**CERTIFICATE OF APPROPRIATENESS**

**Property:** 1018 Preston St, Tract 5 Block 45, SSBB Subdivision. The property includes a historic eight story office building with retail space on the ground floor.

**Proposal:** Alteration – Remove a non-original inset door opening and reinstall it 3’ forward to a new depth of 1’-7” from the exterior wall.

EAST ELEVATION – SIDE FACING FANNIN STREET

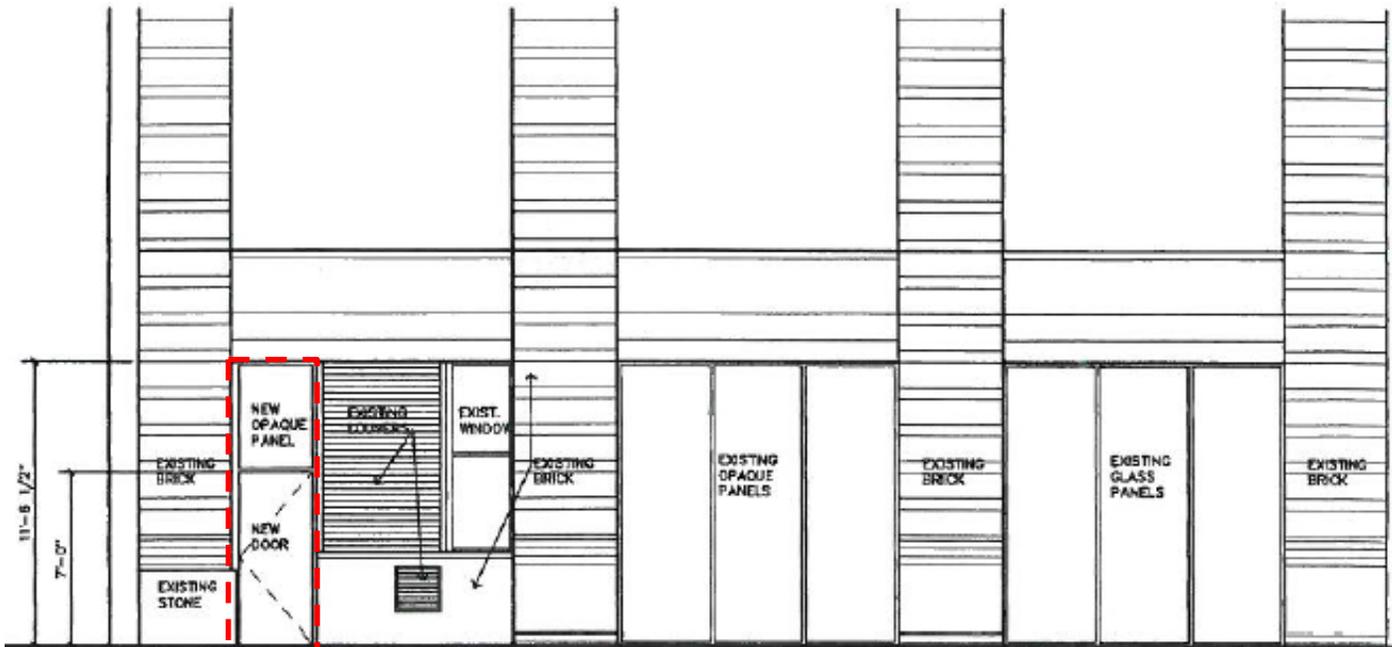
**Side Elevation:** The existing elevation contains a metal door that is set in from the exterior wall 4'-8". The **(East)** alteration reinstalls the door and adds a metal panel above it 1'-7" from the exterior wall.

OPENING DETAIL

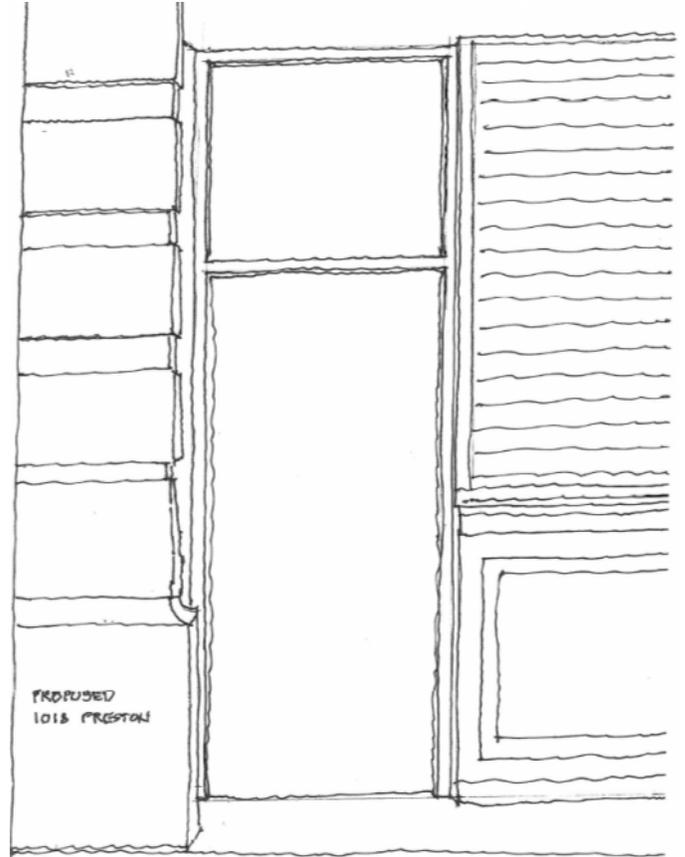
**Shape/Mass:** The existing opening measures 3'-3 1/2" wide by 11'-6 1/2" tall by 4'-8" deep with a 7' tall door. The alteration pushes the door and panel opening toward the exterior wall to a depth of 1'-7".

### FIRST FLOOR PLAN

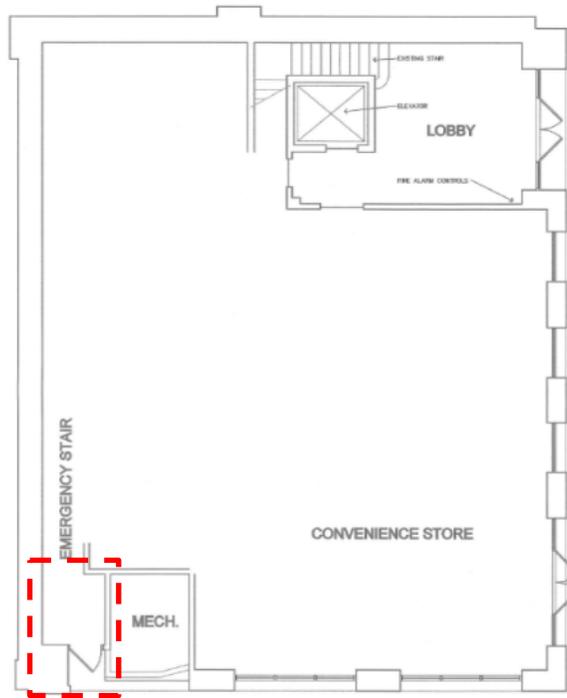
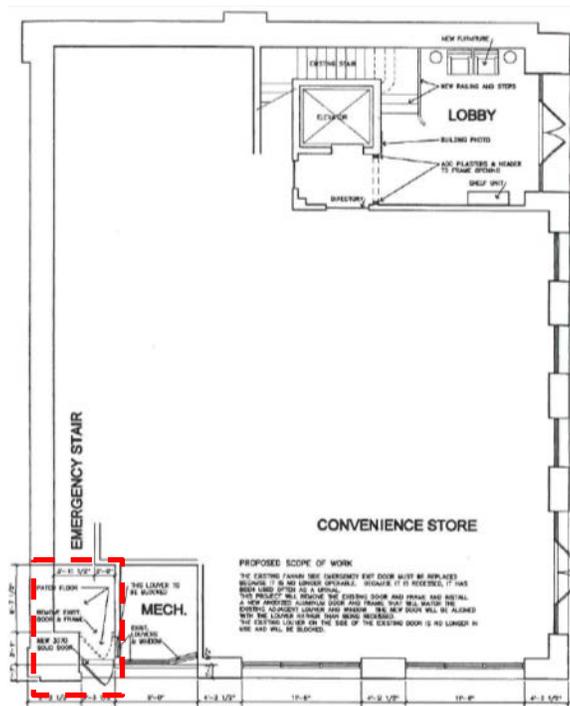
**Windows/Doors:** The existing door is metal and the area above the door is concrete. The new door and panel are metal.
